Request For Information

RFI-069

Subject: BP3 Steel Reconciliation Conf
Project: Steamboat - BV BP Promenade and Goldwalk
Address: 2305 Mount Werner Circle
Steamboat Springs CO 80487 USA
Phone:
To: Jim Gray
Zimkor, LLC
From: Saunders Construction, LLC

1A-S1.00

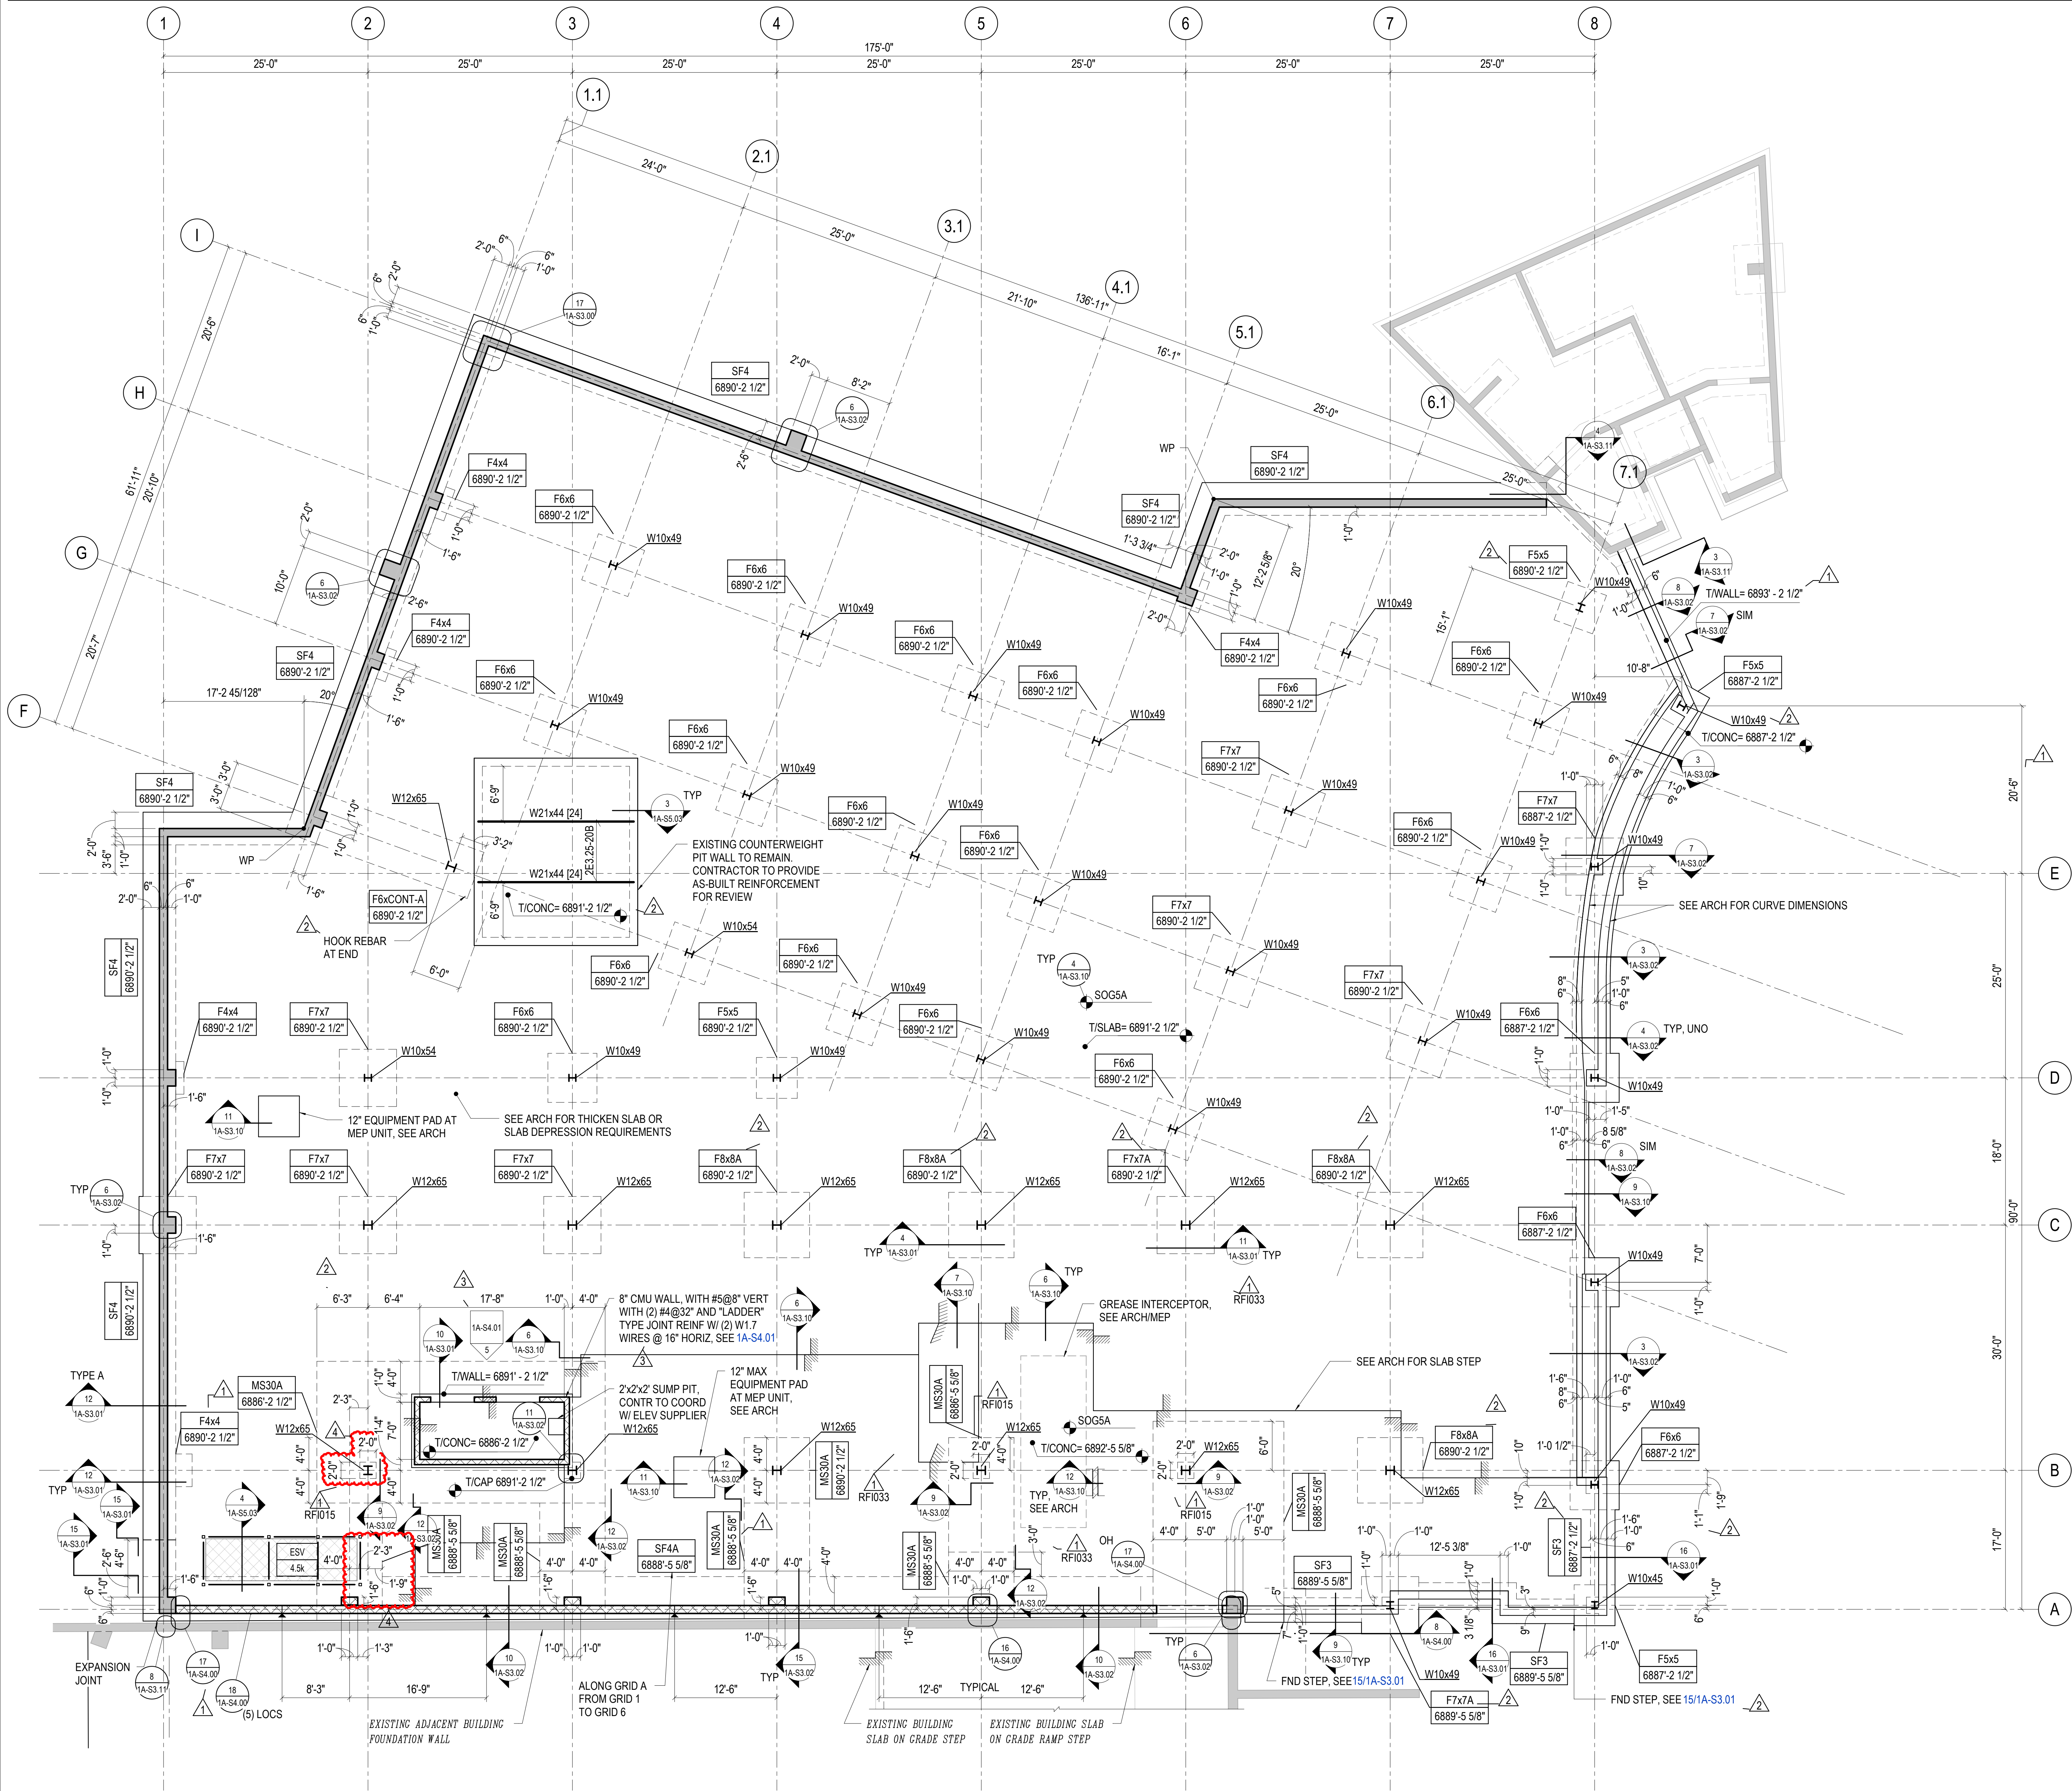
Following release of Promenade Bulletins 5 & 7 further structural steel and foundation changes were needed to be made in order to reduce schedule impact associated with design changes. Please confirm the attached print with updated sheets 1A-S1.00, S1.01, S4.01, S5.02, S5.03 and S5.30 is the final change document to be followed.

CONFIRMED.
KK/MM 8/19/21

SEE ATTACHED DRAWINGS WITH CORREC TITLE BLOCK
JAPPLE GENSLER 8/20/21
